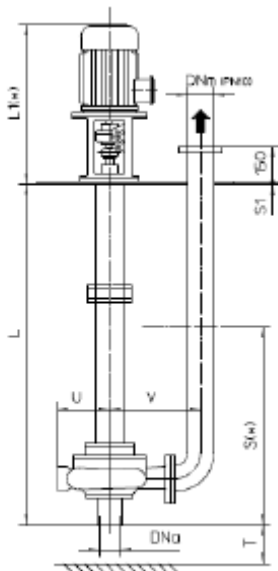
A centrifugal pump with vertical alignment is required. Can you please specify where this pump has to be installed (inside a tank or outside)? Is it used for irrigation? In the case that this pump has to be installed inside a tank with the electric motor on the top cover of the tank, can you specify how long has the connecting pipe to be (length L in the attached picture)?

These pumps are for pumping surface water/water from shallow wells and to be driven by stationery engines specified under items 1a or 1b
